PHILADELPHIA ELECTRIC COMPANY

January 28, 1985

Docket Nos: 50-352
50-353Mr. A. Schwencer, Chief
Licensing Branch No. 2
Division of Licensing
U.S. Nuclear Regulatory Commission
Washington, DC 20555Dr. T. E. Murley, Administrator
Region I
Office of Inspection and Enforcement
U.S. Nuclear Regulatory Commission
631 Park Avenue
King of Prussia, PA 19406SUBJECT: Limerick Generating Station, Units 1 and 2, Organizational Changes
in the PECO Electric Production Department

Attached are draft changes to FSAR Section 17.2, Figures 17.2-2, 3, 4, 5, & 15 and related 260 Series questions which describe the subject changes. These changes have been reviewed and it has been determined that the changes do not reduce the commitments in the QA Program previously approved by the NRC.

FIGURE 17.2-2

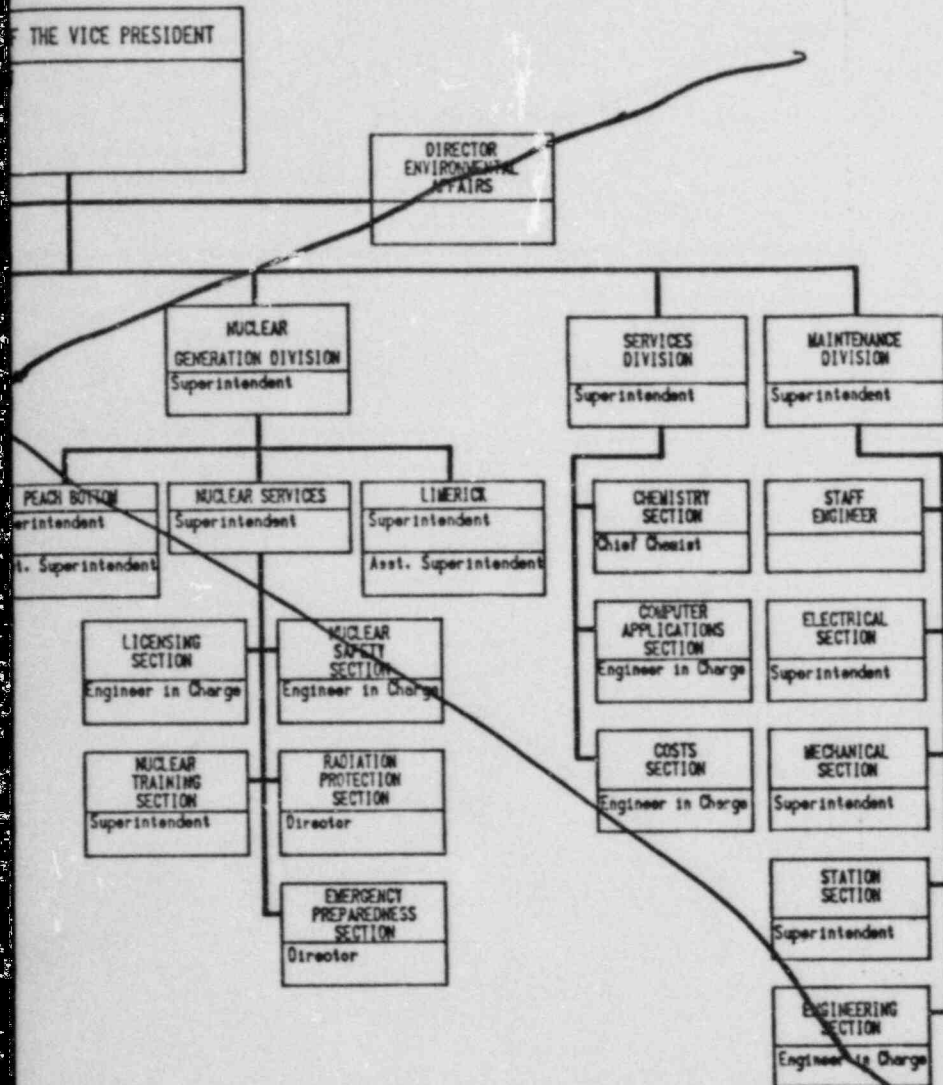
The organization of the Electric Production (EP) Department is shown in Figure 17.2-2.

Manager - Fossil/Hydro
The Department is under the direction of the Vice President - Electric Production, assisted by the Manager - ~~Electric Nuclear~~ *Production and the* Production. They are responsible for the operation, maintenance and modification of the Company's electric generation facilities and establishment and implementation of Electric Production Department Quality Assurance Program, goals, and objectives.

The Electric Production Department is composed of ~~seven~~ *six* Divisions: Fossil/Hydro Generation, Quality Assurance, Services, ~~Steam Heating~~, Nuclear Generation, Maintenance, and System Operation.

FIGURE 17.2-3

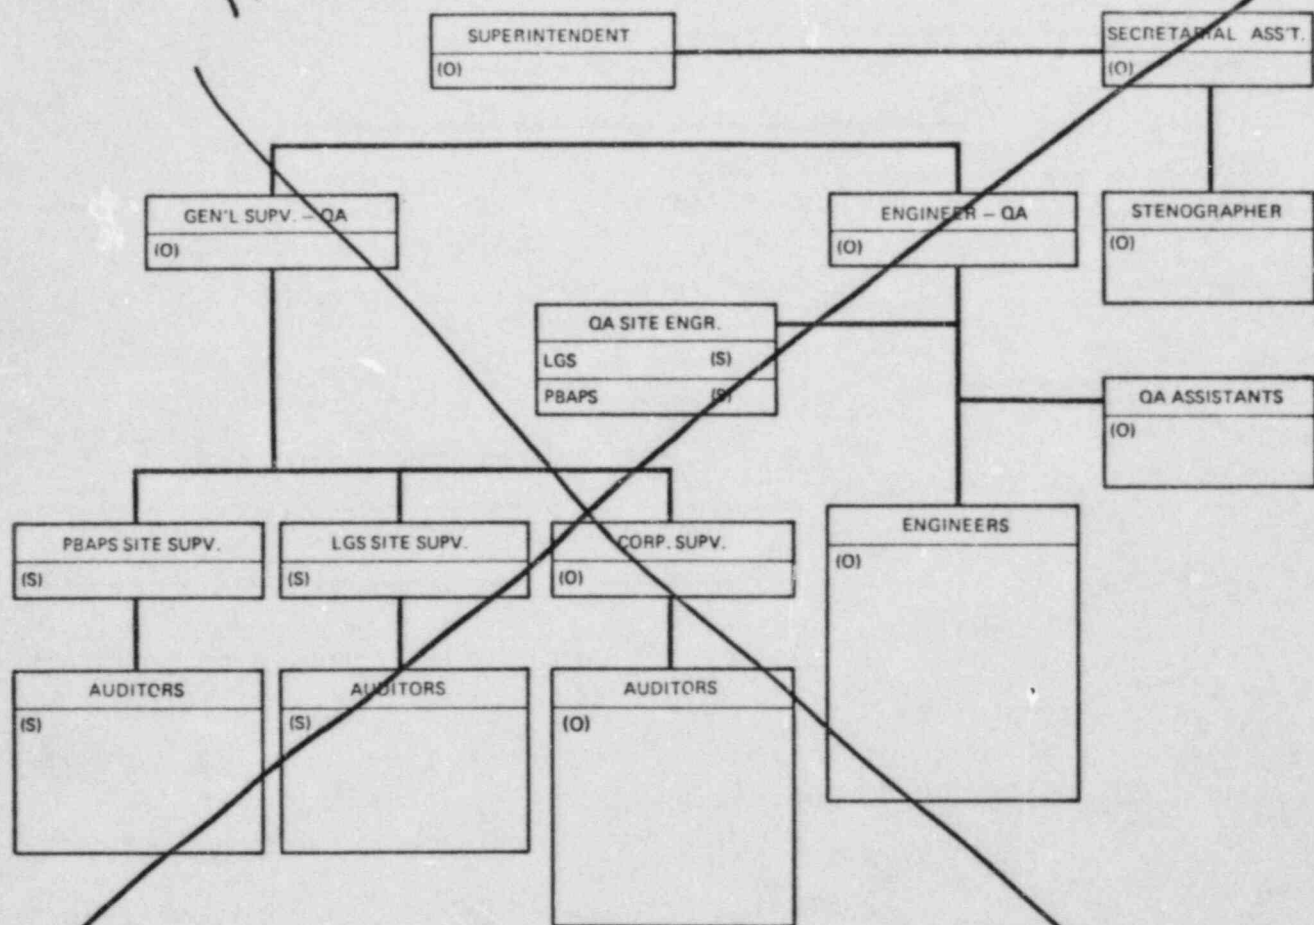
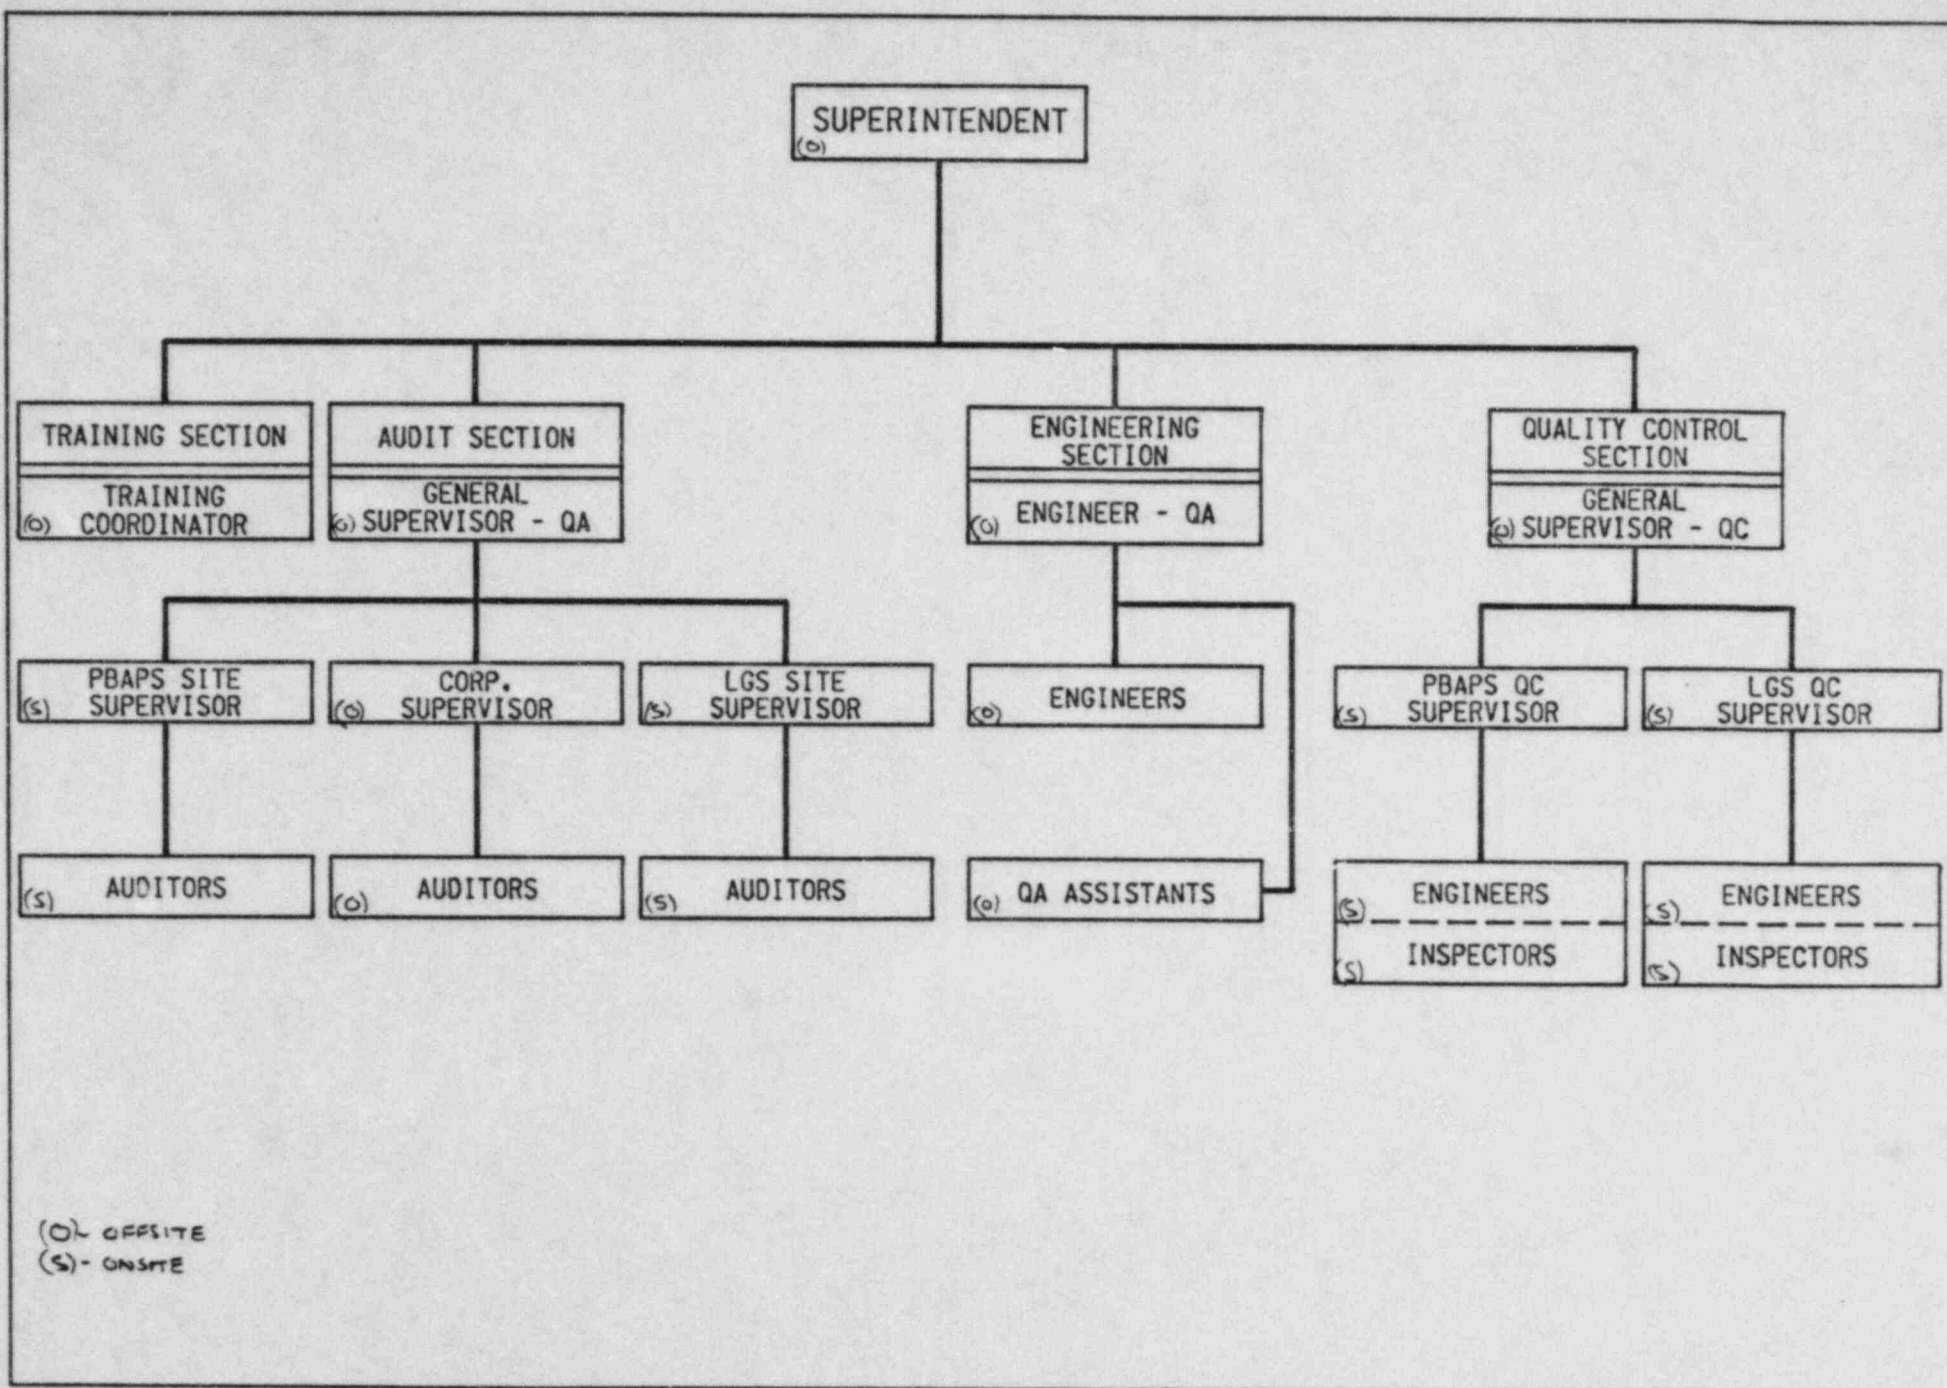
The Quality Assurance Division (Figure 17.2-3) is responsible for the overall Quality Assurance Program of the Electric Production Department within the framework of corporate Quality Assurance Policy as set forth in the Introduction.

Insert (B)

FIGURE 17.2.4

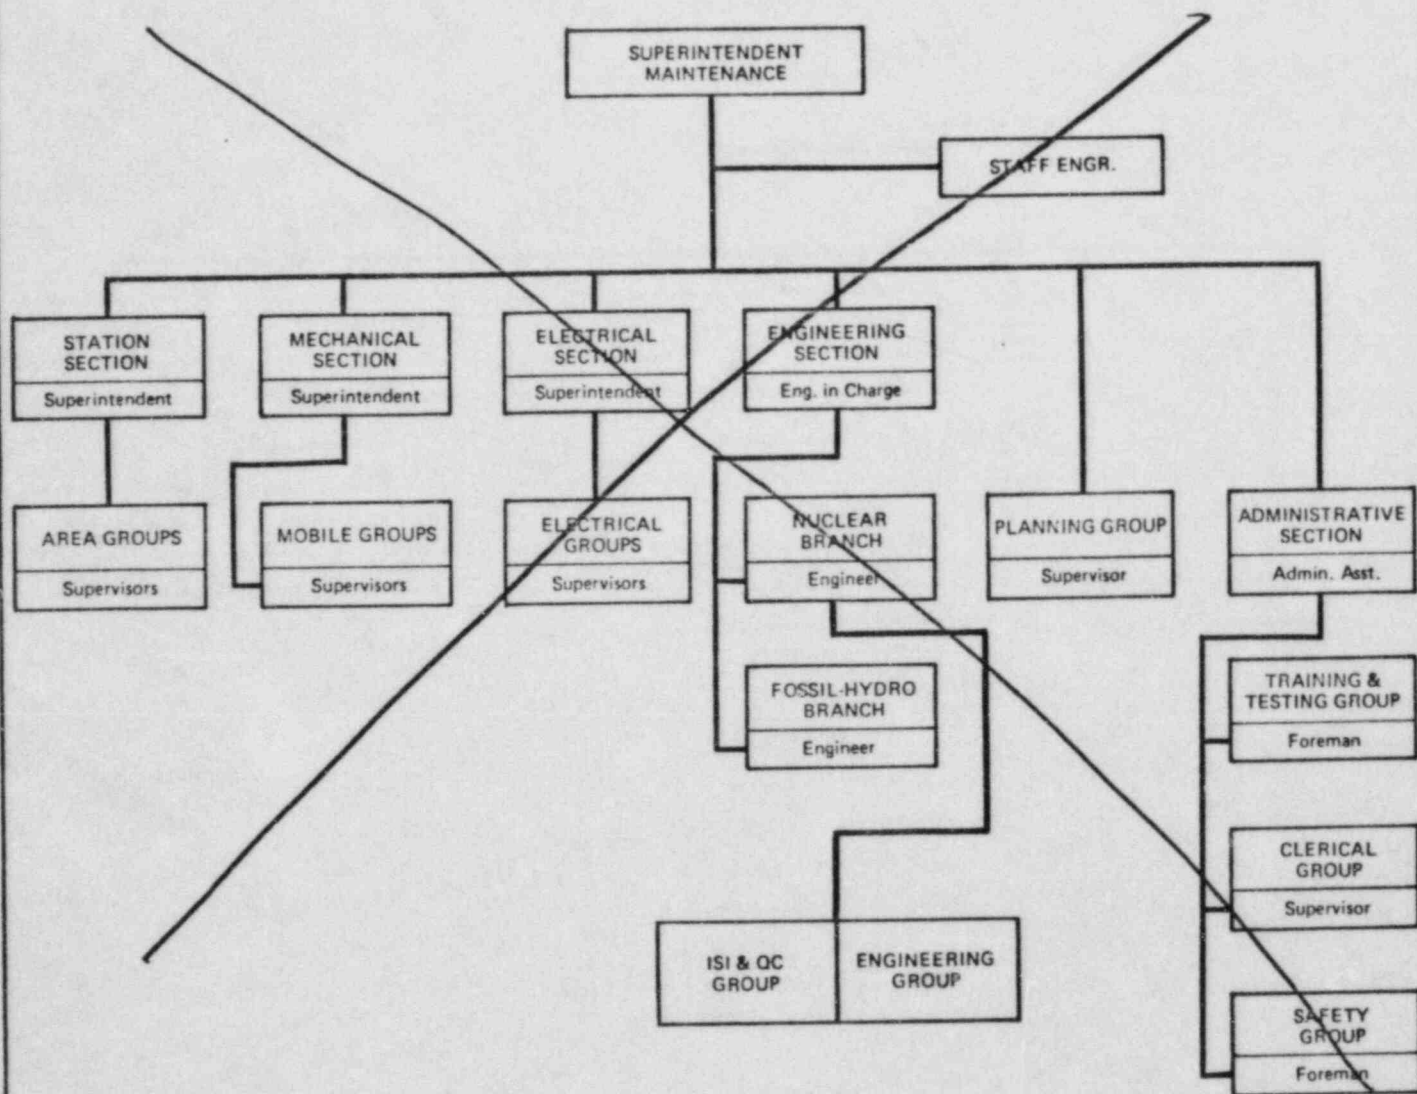
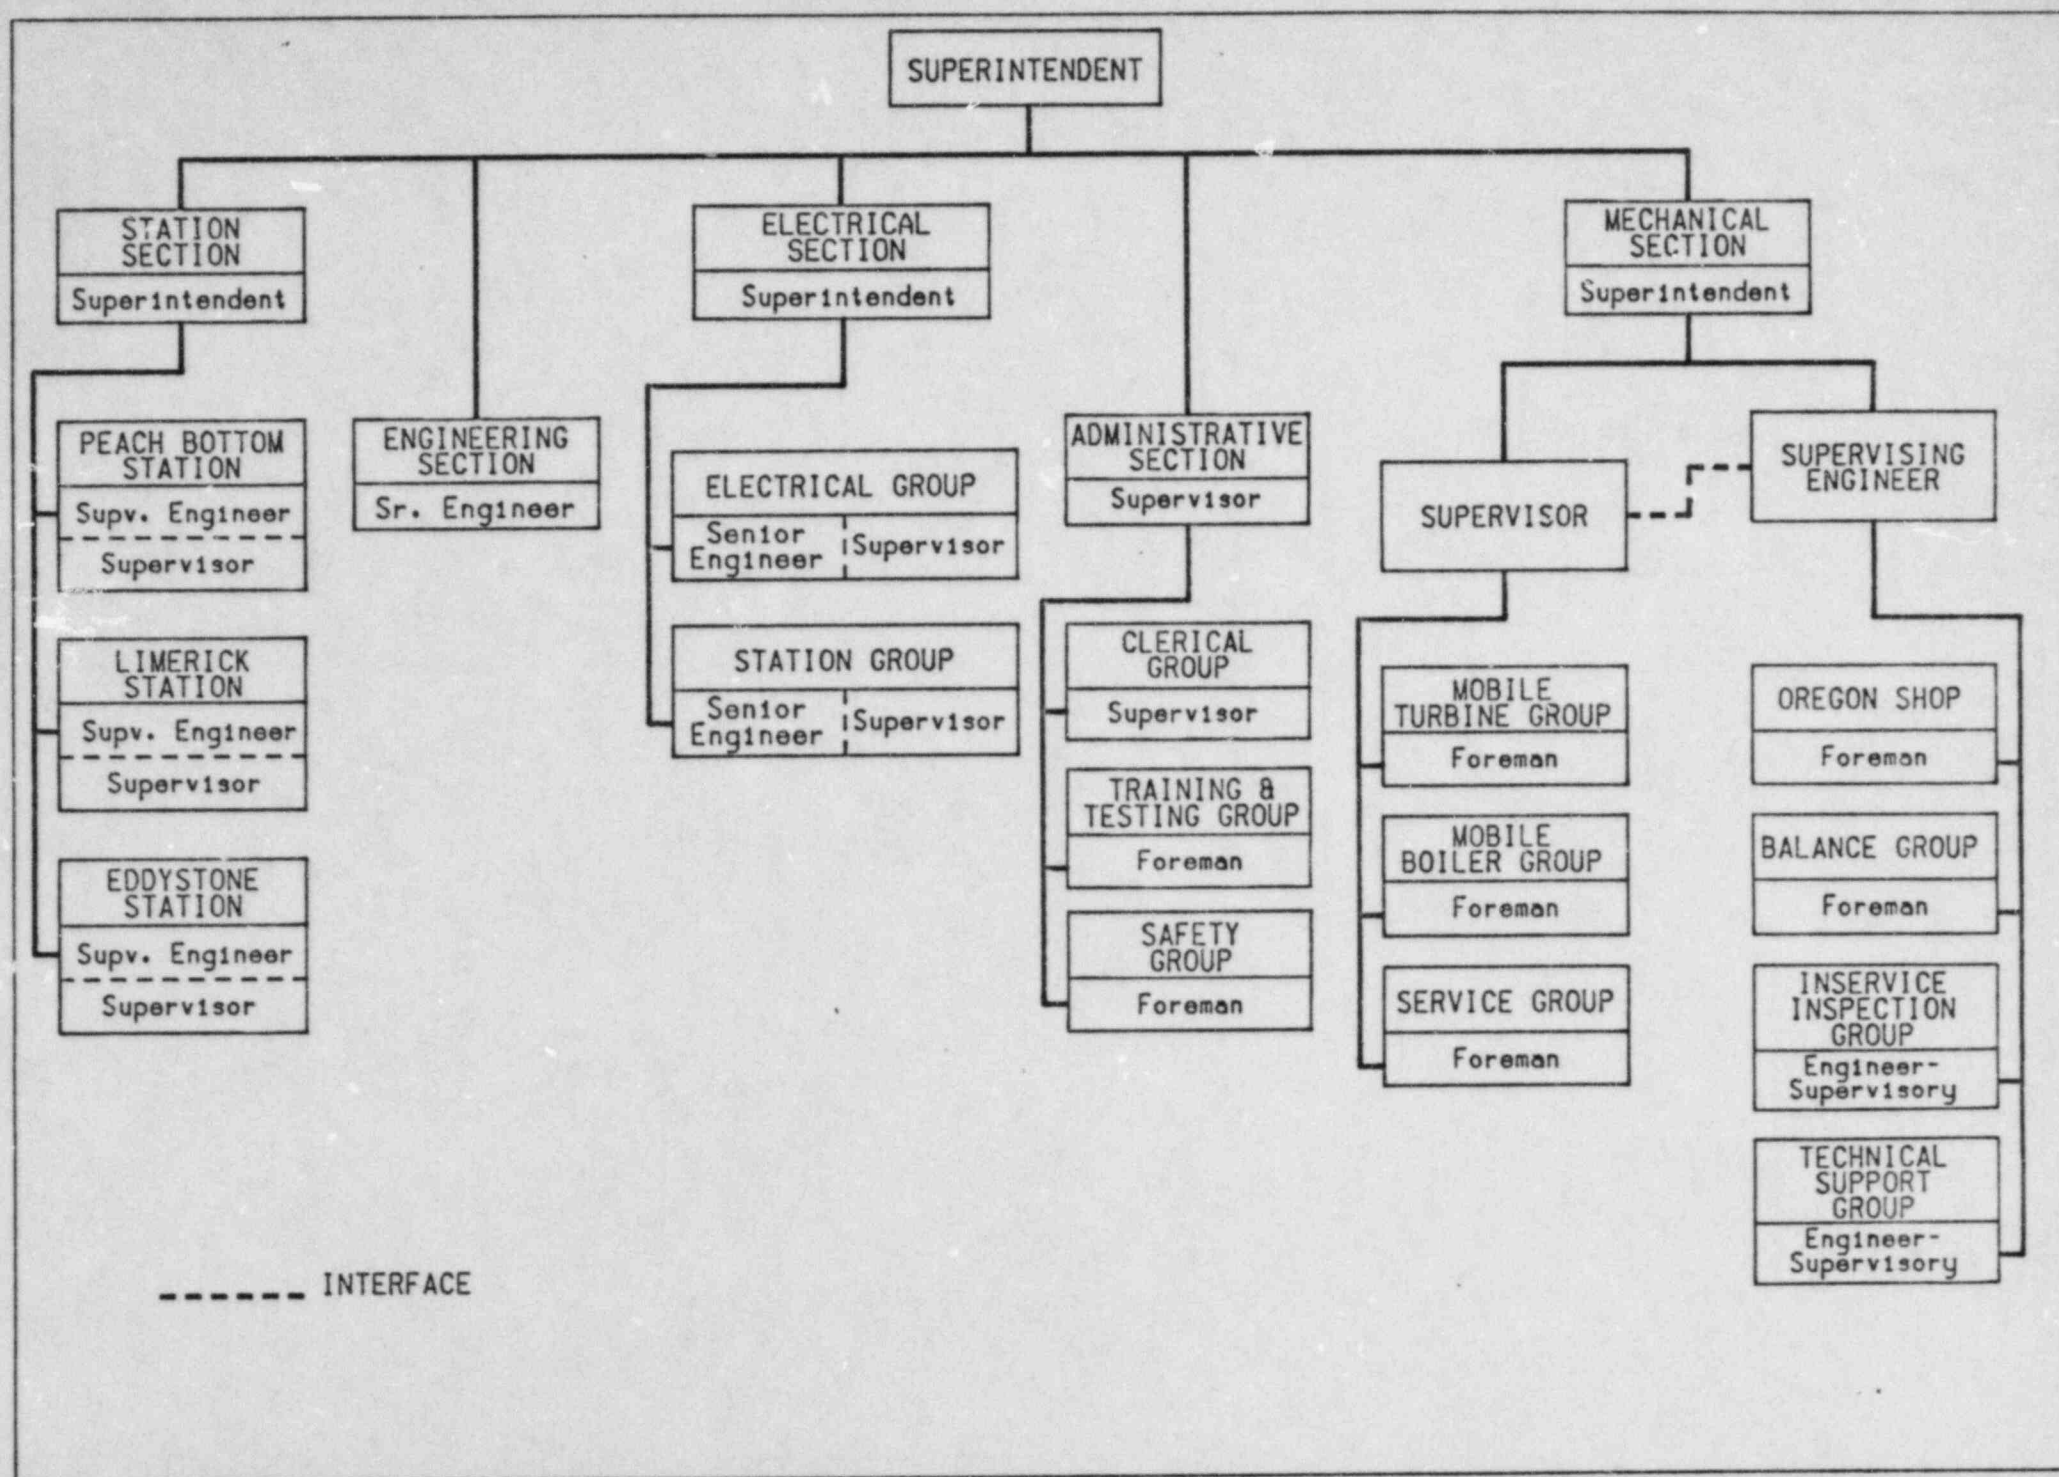
The Maintenance Division (Figure 17.2-4), under the ^{supervision of a} ~~Superintendent who reports to the Office of the Vice President,~~ ^{Manager, Fossil/} ~~Electric Production,~~ is responsible for the Maintenance activities at all generating stations, ^{and} steam plants, and certain ^{heating} ~~substations.~~ The Division is composed of ~~a staff engineer and~~ five sections: Station, Mechanical, Electrical, Engineering, and

Insert (C)
